**PROCUREMENT OF EQUIPMENT FOR GENERAL HOSPITAL IN
ARANDJELOVAC
(PROCUREMENT NO. IOP/60-2021/UHI)
19th April 2022**

Clarification no. 6

Regarding the list of questions that the Employer, Public Investment Management Office Belgrade, No. 11 Nemanjina street, have received from the potential bidders, concerning the procurement procedure: **Procurement of equipment for General Hospital in Arandjelovac” IOP/60-2021/UHI**, we give you the following answers:

Figure 19 shows the DQE averaged in the 2 orthogonal directions for a range of incident air kerma to the detector. The MTF and DQE measurements were interpolated to show values at standard frequencies in Table 15.

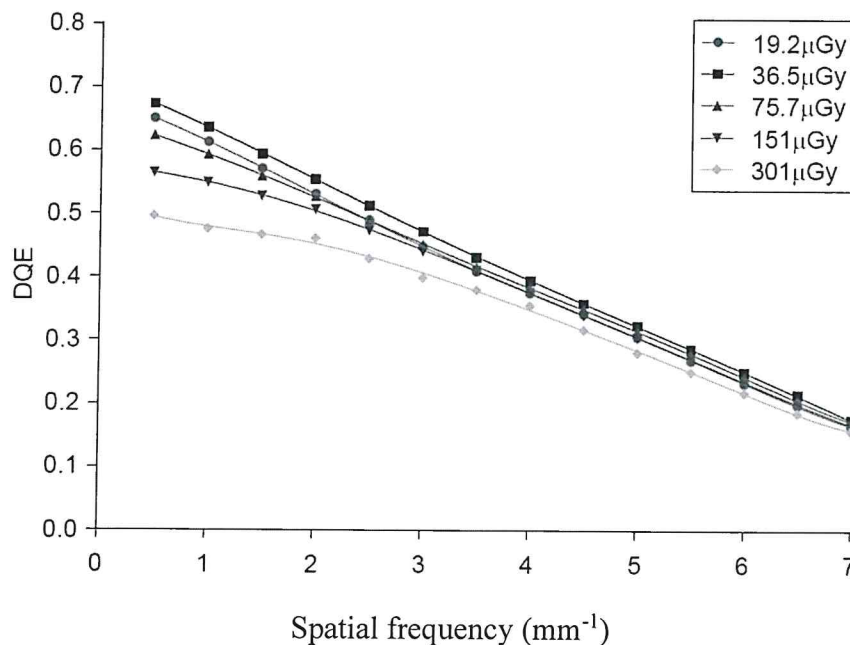
Here, it is clearly visible that DQE is above 65% for 0.5 lp/mm, but for the 19.2μGy and 36.5μGy functions. At the same time in the Table 15. Average of orthogonal directions of MTF and DQE measurements at spatial frequencies up to the Nyquist frequency, they show the *average* DQE for 75.5μGy, that is 62% for 0.5 lp/mm.

The message of this claim is that DQE is just one of the parameters that define the quality of the detector and accordingly the mammography system, even that it defines it, but explicitly under some other parameters that *are not expressed* in the Technical Specification Request of the Purchaser.

Answer: After detailed analysis we will partially accept suggestion, so ID 38 will be like following: DQE@ 0,5 lp/mm min. 62%.

Figure 13. MGD for a 60mm equivalent breast to reach minimum acceptable image quality standard for 0.1mm detail. (Error bars indicate 95% confidence limits.)

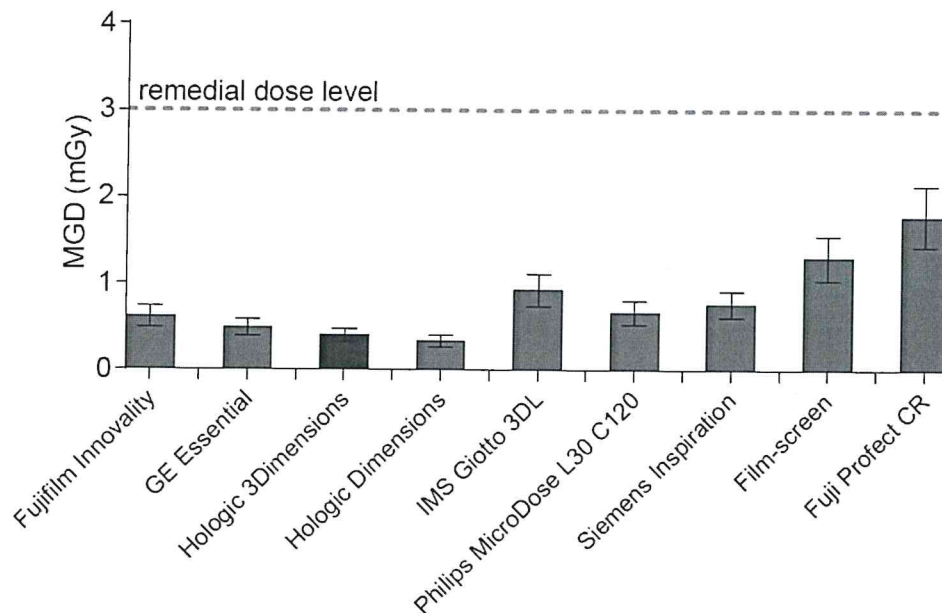
As you can easily see, the lower the column of each diagram, the better the system is.

Our suggestion is either to erase the requested parameter in Technical Specification Requested for LOT 4, Item 2, Digital Mammography System, specification number 38: "DQE@ 0,5 lp/mm min. 65%", or simply to accept our suggestion: "DQE@ 0,5 lp/mm min. 60%".
